INSERVICE INSPECTION

REV. 5	ISO. NO: MCFI-1N153	BR	AK	SP	BR
BUILDING: REACTOR R-4 1R2	DUKE PIPING CLASS: A+B ASME SECT. III	DATE	DATE	DATE	DATE
	SYSTEM SYMBOL: NI - SAFETY INJECTION	11/20/80	11/20/80	11/20/80	11/20/80
	PIPING SPEC: NI-30+36 PS 2501.1	11/20/80	11/20/80	11/20/80	11/20/80
	DRAWING NO: MC-1414-09-22-00	11/20/80	11/20/80	11/20/80	11/20/80
	PROJECT: MCGUIRE	11/20/80	11/20/80	11/20/80	11/20/80

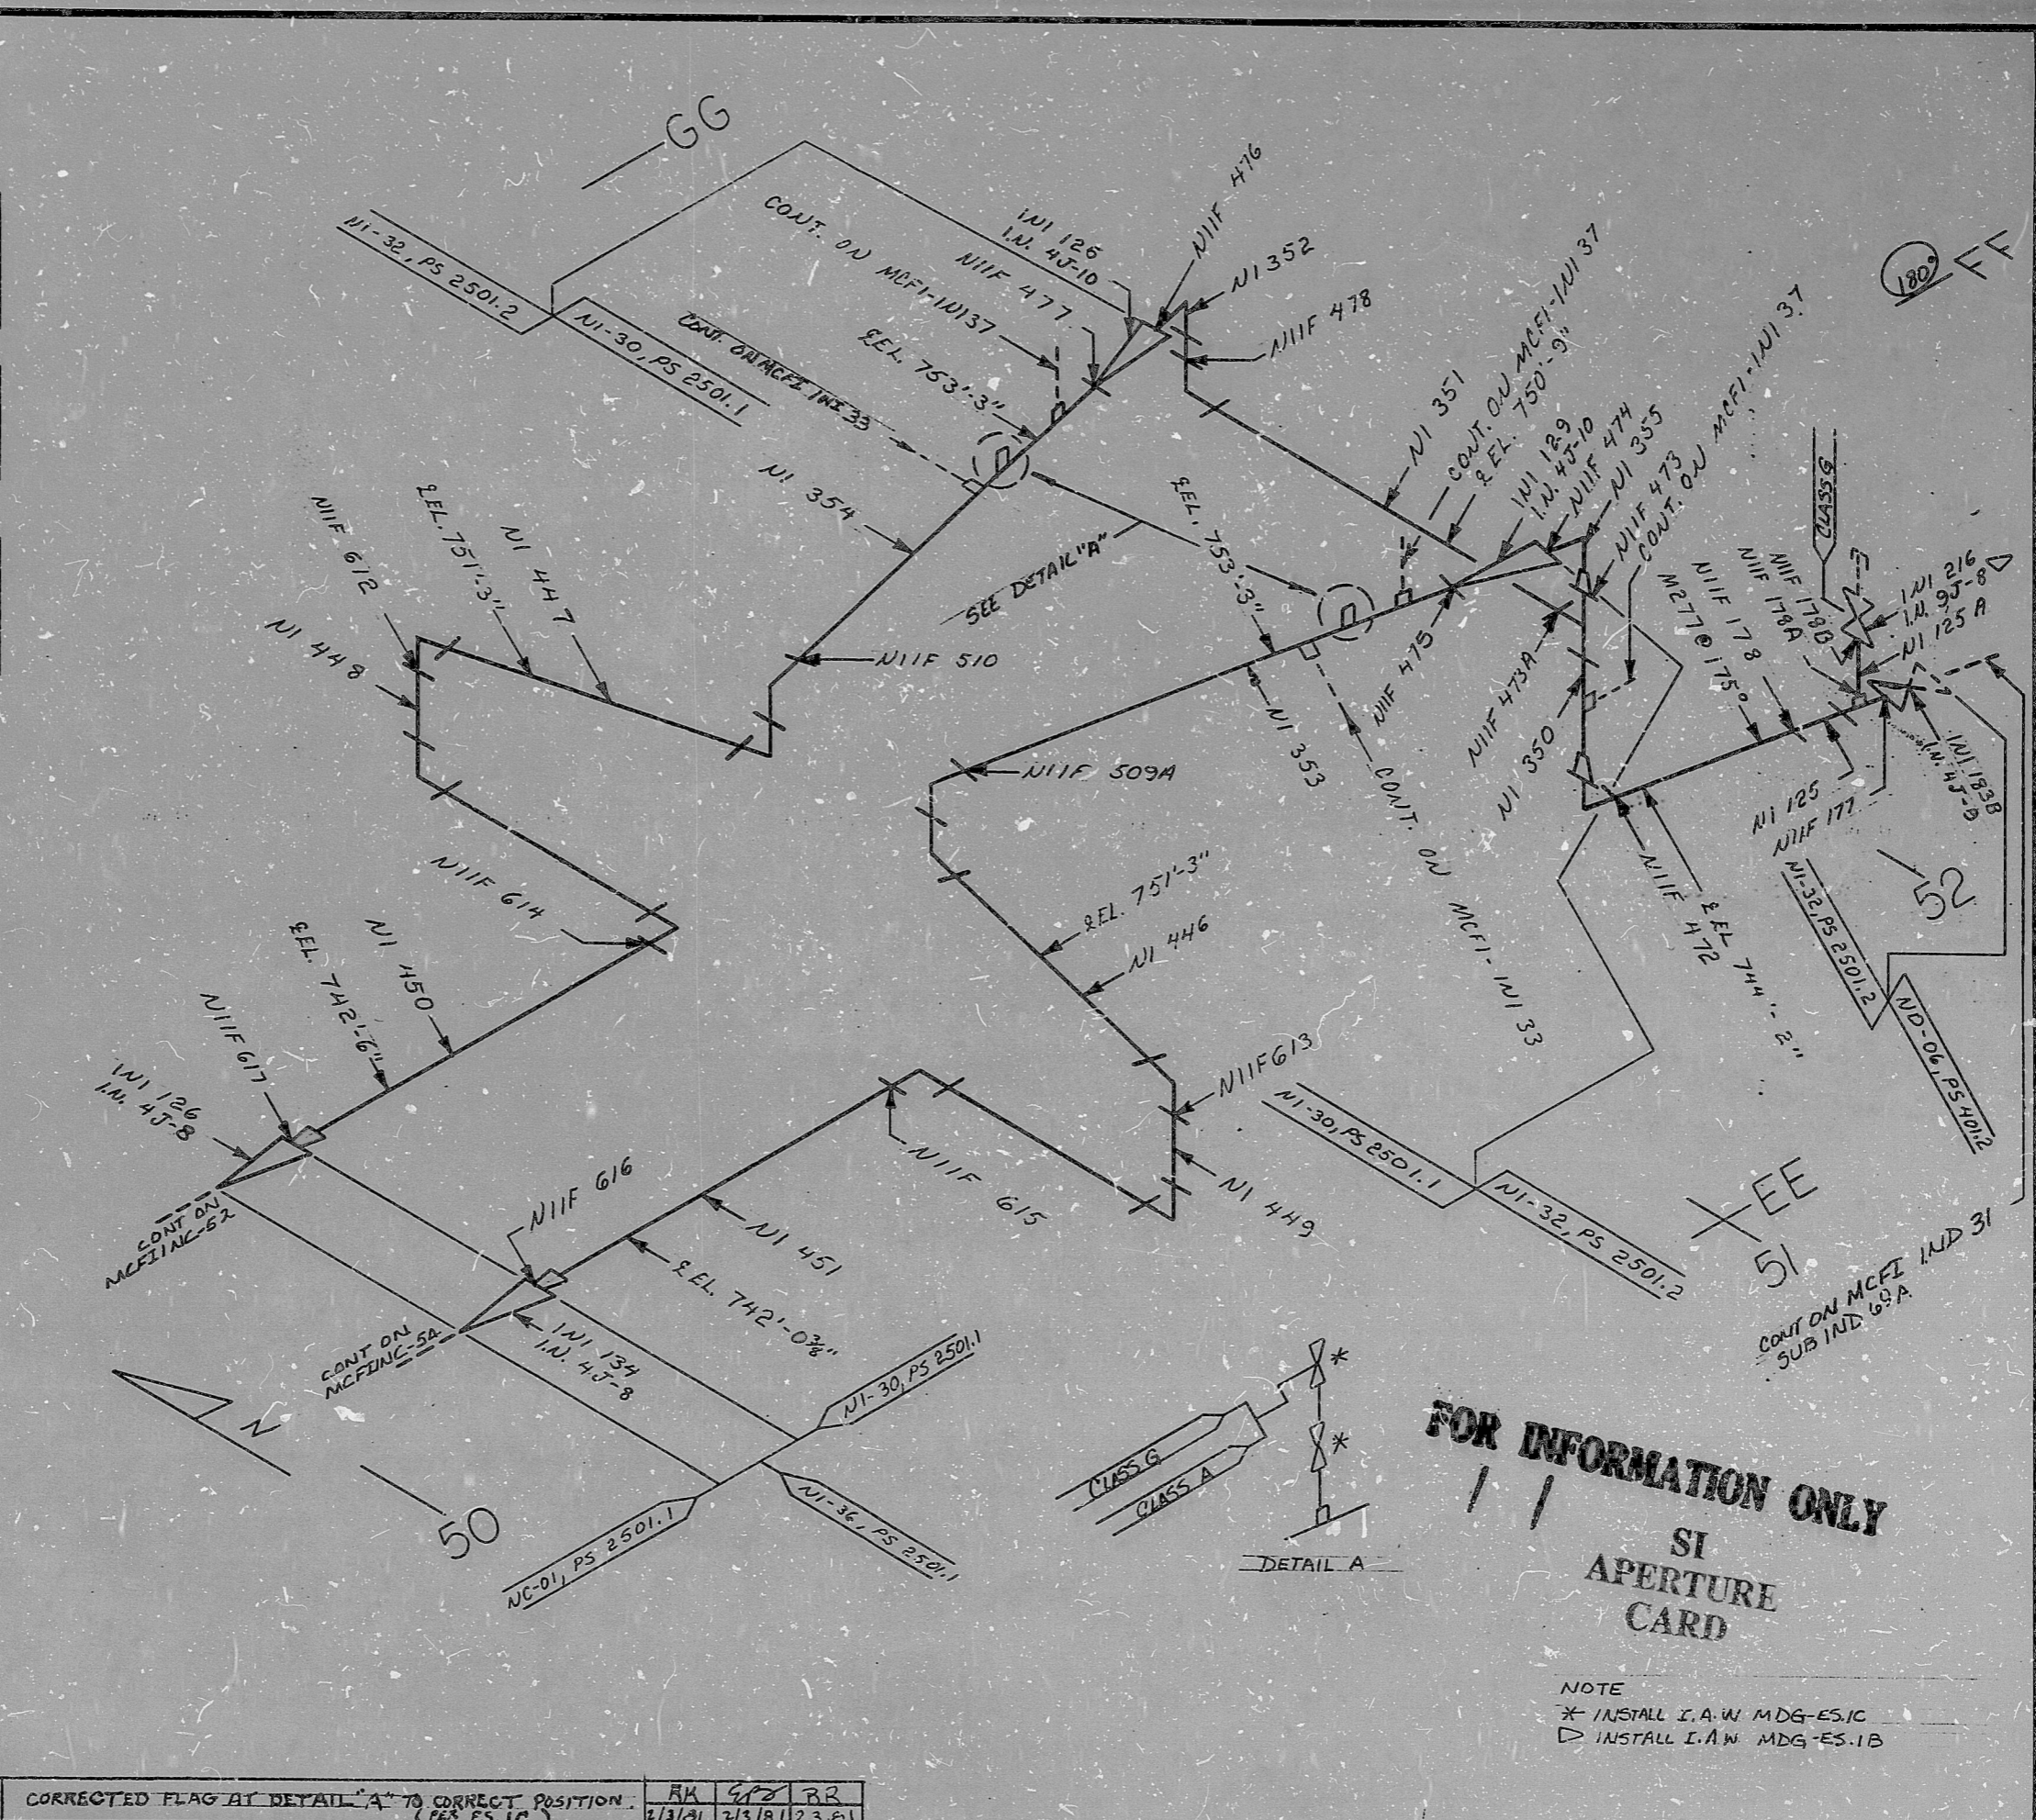
NO. 5	CORRECTED FLAG AT DETAIL "A" TO CORRECT POSITION. (PER ES.1C)	AK	SP	BR
		2/3/81	2/3/81	2/3/81
